SUBJECT: NuScale Power, LLC Response to NRC Request for Additional Information No. 304 (eRAI No. 9189) on the NuScale Design Certification Application

NuScale Response to NRC Request for Additional Information eRAI No. 9189

eRAI No.: 9189

Figure 5.1-2: Reactor Coolant System Simplified Diagram

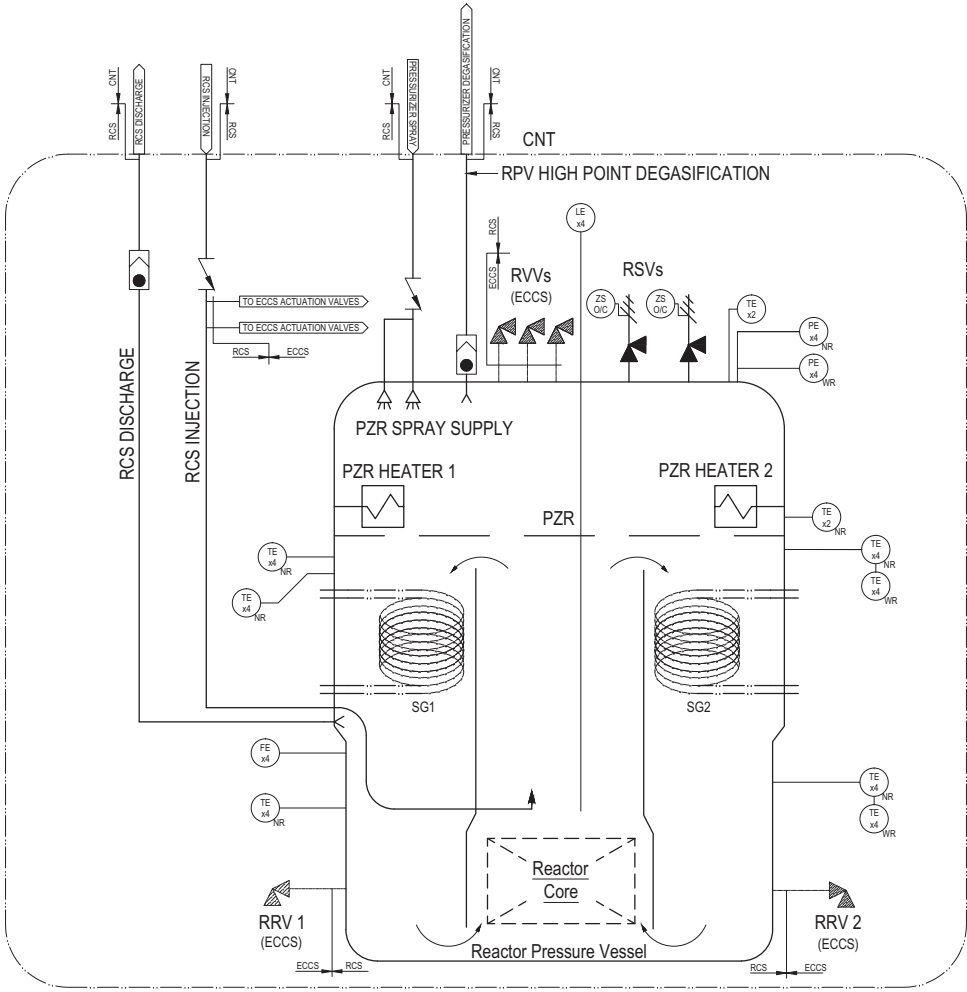
Part 1.) In FSAR Tier 2, Figure 5.1-2, the applicant shows a single branch off of the CVCS RCS Injection line that goes to the ECCS Actuator Valves. In FSAR Tier 2, Figure 6.3-1, the applicant shows two branches from the RCS that go to the ECCS valves. The staff cannot determine how a single branch, from one drawing connects to two branches on a different drawing, and thus cannot ascertain whether or not the system has been designed to minimize abnormal leakage. The staff requests the applicant to update the FSAR with the appropriate connection between Figure 5.1-2 and Figure 6.3-1 so that the staff can logically verify the line's adequacy.

There are two branches from the chemical volume control system (CVCS) reactor coolant system (RCS) injection line to the emergency core cooling system (ECCS). FSAR Tier 2, Figure 5.1-2 has been updated to show both branches.

Figure 6.3-1: Emergency Core Cooling System

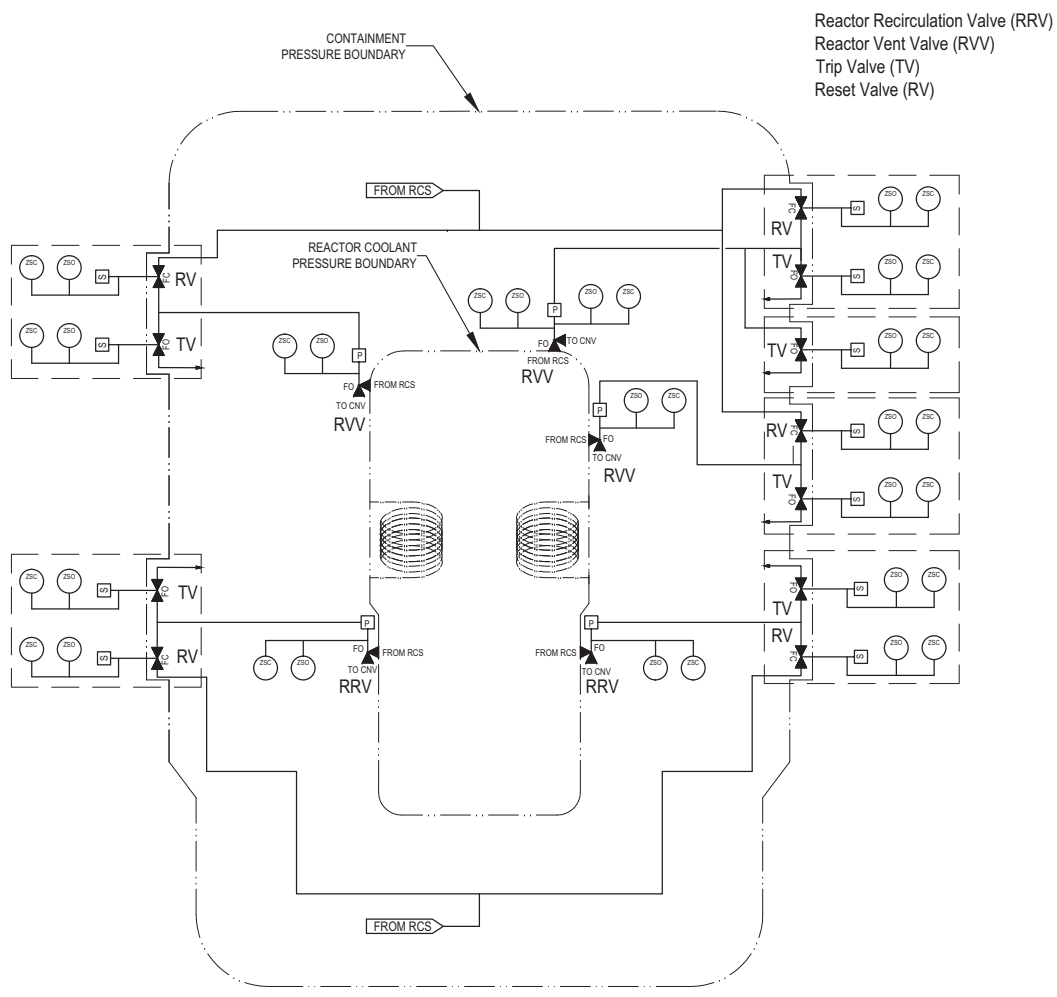
Part 2.) In FSAR Tier 2, Figure 6.3-1, the applicant shows the CVCS/ECCS reset lines going to both RRV trip valves, and shows the RRV reset valves discharging into containment. This display of the RRV reset/trip lines and valves is directly opposite of how it is displayed for the RVVs on the same figure. The staff cannot determine if the reset/trip lines and valves are configured correctly for the RRVs showed in Figure 6.3-1. The staff requests the applicant to update the FSAR with the appropriate reset/trip line and valve configuration in Figure 6.3-1.

Part 3.) In FSAR Tier 2, Figure 6.3-1, the staff notes that the ECCS line between the reset valve, trip valve, and associated ECCS valve is normally isolated from the CVCS during normal operation. The staff notes that the CVCS is used to reset the ECCS valve by providing pressurized CVCS water to this ECCS line. After this line becomes isolated from the CVCS, the CVCS no longer maintains chemistry of this water. The staff notes that contaminants could accumulate in this line due to stagnation and may affect ECCS valve operation. The staff cannot determine if this line, which contains stagnate CVCS water, maintains appropriate chemistry throughout the operation of the plant. The staff requests the applicant to provide the chemistry requirements of these lines and valves (i.e. reset line/valve, trip line/valve, and ECCS line/valve) and justify how the CVCS meets those requirements when the CVCS water has stagnated within those lines and valves. The staff requests the applicant to update FSAR Tier 2, Section 9.3.4 with this explanation justifying how the CVCS adequately maintains the water chemistry used to reset the ECCS valves over the operation of the plant.

FSAR Tier 2, Figure 6.3-1 was in error and has been updated to indicate the correct relative locations of the trip valves and reset valves.

Startup and chemistry control of a NuScale power module (NPM) are the responsibility of a COL applicant, however, the NPM, ECCS, and chemical volume control system (CVCS) designs described in the FSAR provide the necessary capabilities for chemistry control of the RCS and the ECCS stagnant lines. The NuScale RCS has no local high points for trapping pockets of air and the NPM is equipped with permanently installed vacuum pumps in the containment evacuation system. NPM startup procedures include an initial vacuum degasification phase to remove air in the NPM and to reduce the dissolved oxygen of the RCS water, as described in FSAR Tier 2, Section 9.3.6.2.3. The ECCS valve hydraulic lines are filled with water from the RCS CVCS injection line before hydrazine addition. This water is expected to have dissolved oxygen above 150 ppb. However, the reset valves can be subsequently opened during startup or normal operation to flush the ECCS hydraulic system with filtered and purified CVCS injection flow. The ECCS system remains operable when the reset valve is open because the hydraulic line to the reset valve is much smaller than the trip valve line, preserving the valve safety function despite additional flow from the reset line. This ECCS flushing operation has negligible effect on the operation of the module, and can be performed anytime CVCS injection is occurring (which is continuous during normal operation). Therefore, at any point during normal operation or startup, the ECCS hydraulic lines can be flushed by opening the ECCS reset valves (as shown in FSAR Tier 2, Figure 6.3-1).
